MOUNTAIN
HOUSING GROUP

LOT 640C
TELLURIDE MOUNTAIN VILLAGE

SHEET TITLE:
BLDG 1 FLOOR PLANS

A2.1

1 BUILDING 1 - UPPER LEVEL
1/8"=1'-0"

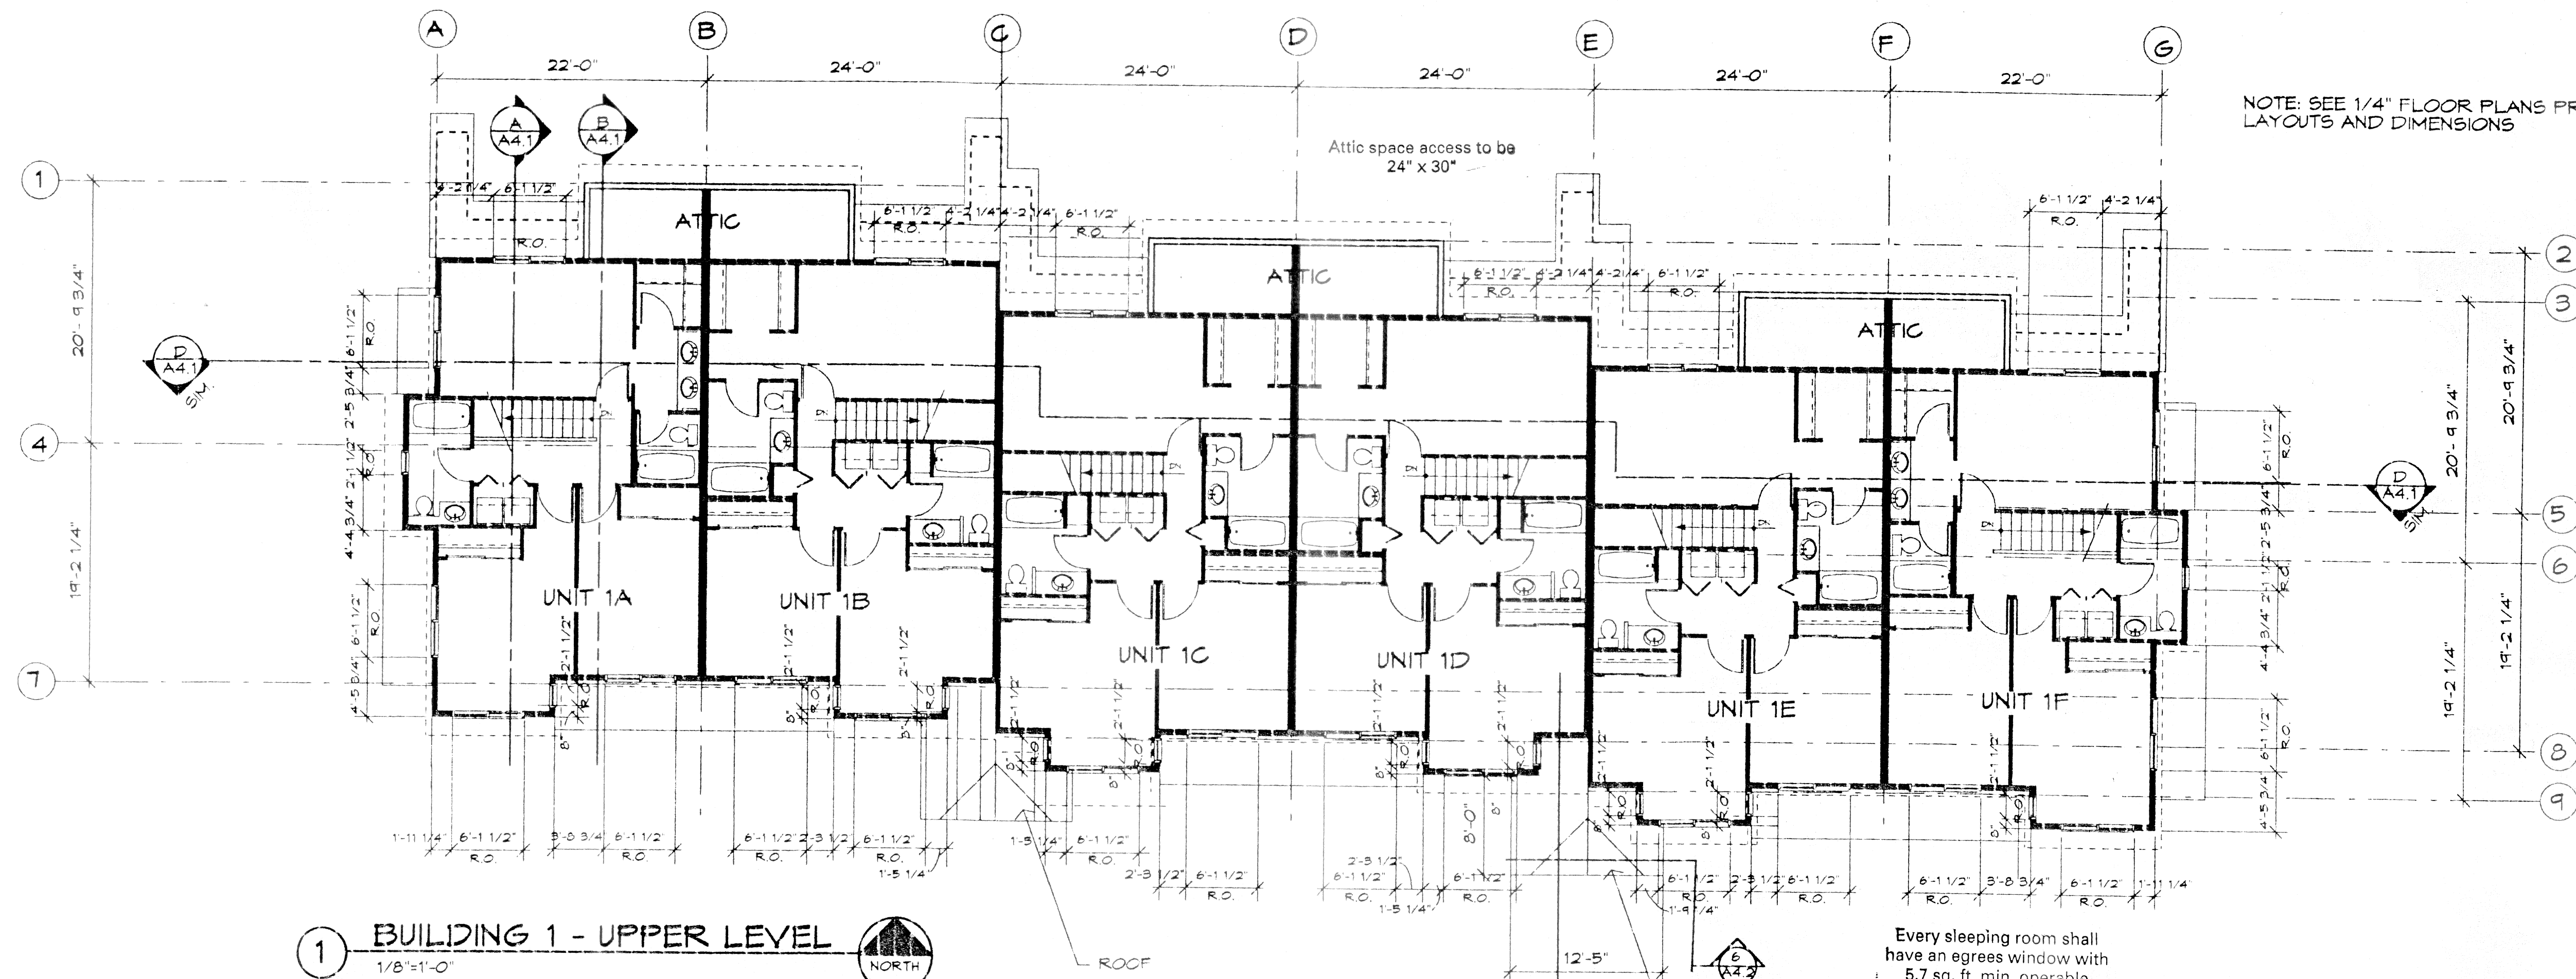
Handrails: Stairways with 4 or more risers shall have a handrail on at least one side at 34" - 38" above of tread Sec. 3306 (j) 3

Every sleeping room shall have an egress window with 5.7 sq. ft. min. operable area. Min. 20" wide and 24" high dimensions are required. Sill height max. 44" off floor Sec. 1204

2 BUILDING 1 - LOWER LEVEL
1/8"=1'-0"

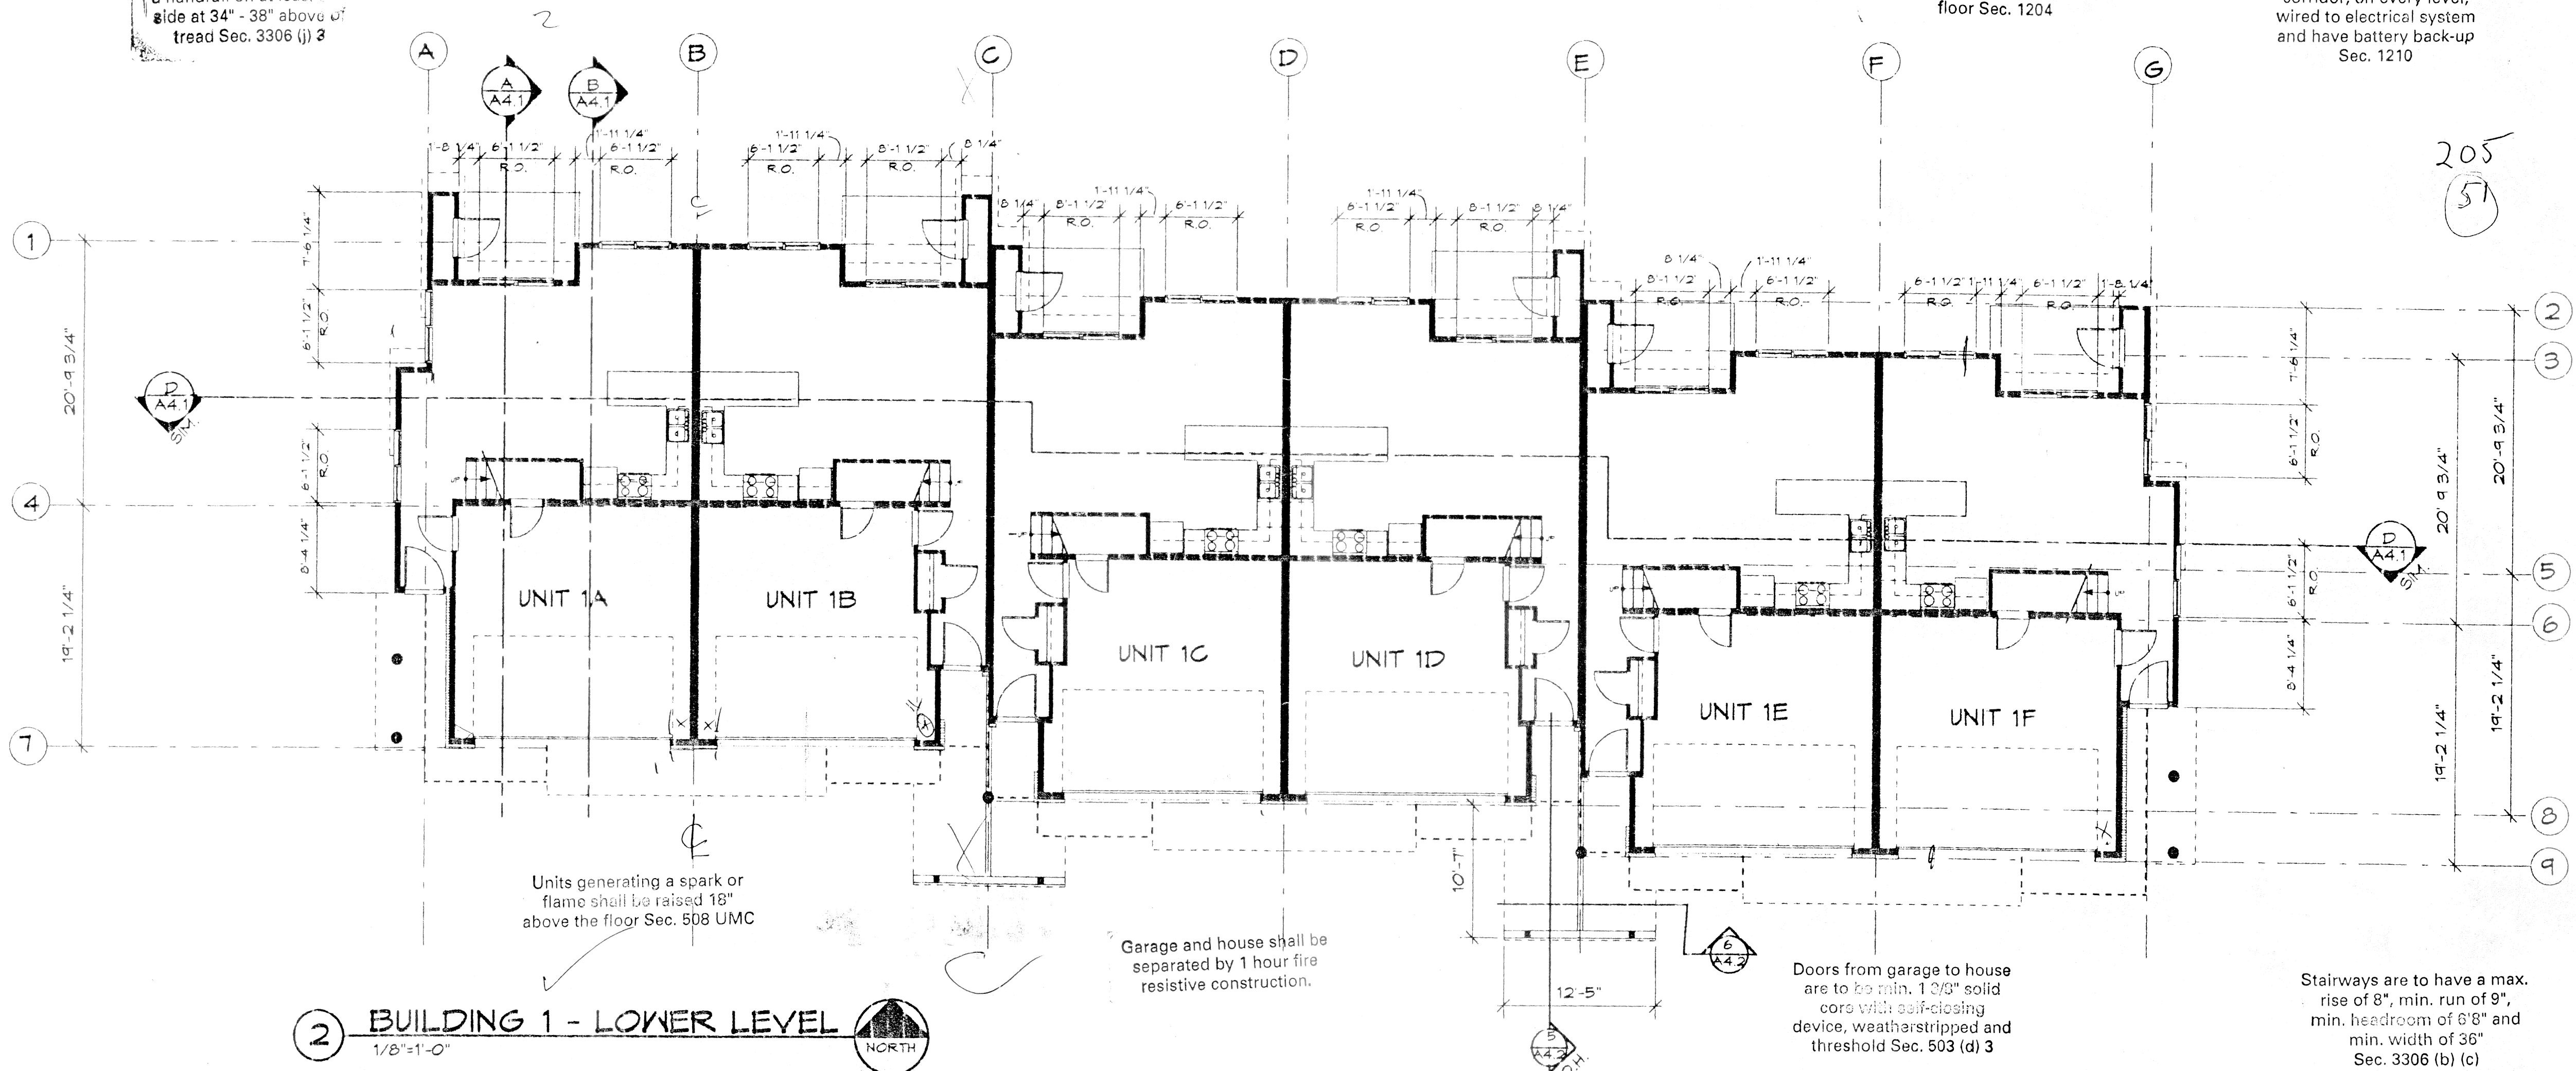
Smoke detectors are required in each bedroom, bedroom corridor, on every level, wired to electrical system and have battery back-up Sec. 1210

Units generating a spark or flame shall be raised 18" above the floor Sec. 508 UMC

Garage and house shall be separated by 1 hour fire resistive construction.

Doors from garage to house are to be min. 1 3/8" solid core with self-closing device, weatherstripped and threshold Sec. 503 (d) 3

Stairways are to have a max. rise of 8", min. run of 9", min. headroom of 6'8" and min. width of 36" Sec. 3306 (b) (c)
